Re: Proposed Resolution Nos. R3-208-0060 and R3-208-0061
192 and 194 San Remo Road, Carmel Highlands, CA
Monterey County PLN 060251, Combined Development Permit Application
Monterey County PLN 040050, Combined Development & Lot Line Adjustment
Current Monterey County Assessor Parcels 243-181-005 and 243-181-006

Item No. 27 Attachment No. 6
WDR Moeller Residence
192 San Remo Rd.
R3-2008-0060
December 4-5 2008 Meeting

Enclosure: Copy of Assessor's Map Book 243, Page 18

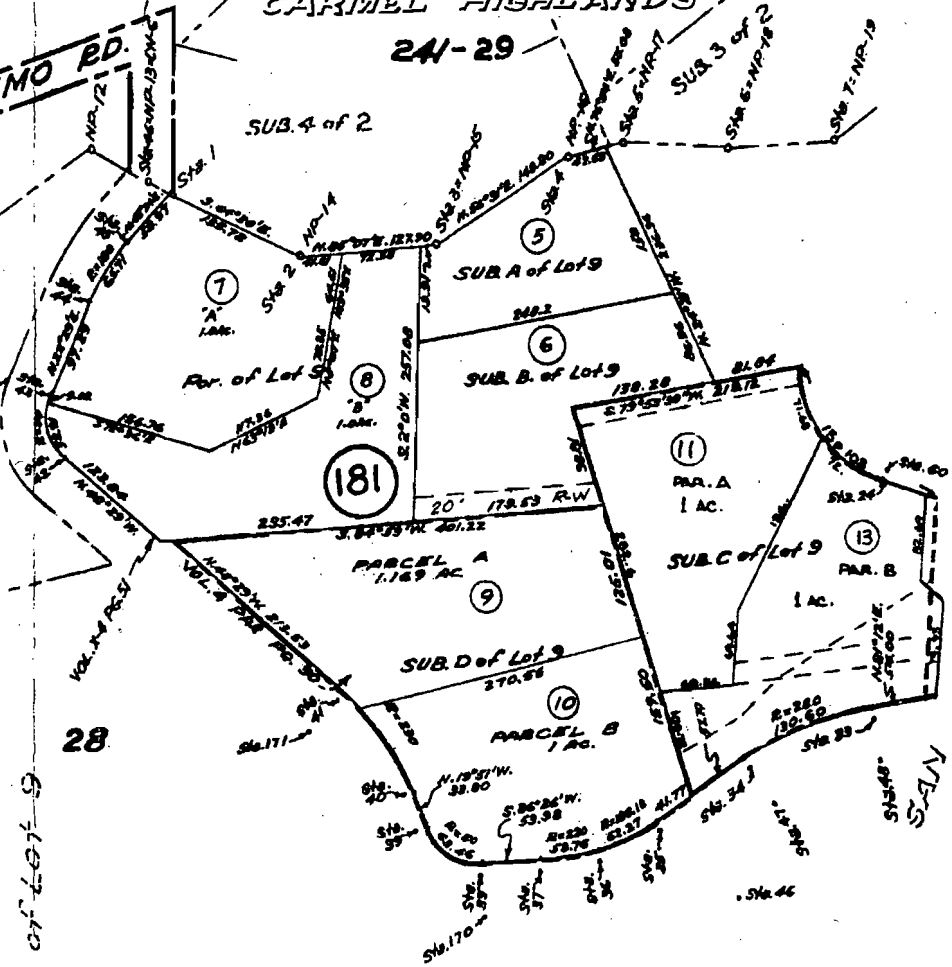
Enclosed is a copy of the current Monterey County Assessor's map showing the configuration of the existing parcels. While it may be more efficient from your agency's viewpoint to approve both

of these parcels simultaneously, you must recognize that the parcel boundaries (and hence the setbacks and entire site plan) are based on a boundary configuration that does not exist, and may never be approved. It would seem most reasonable for the applicant to pursue the approval of an advanced wastewater system only after the basic parameters of the site are factual.
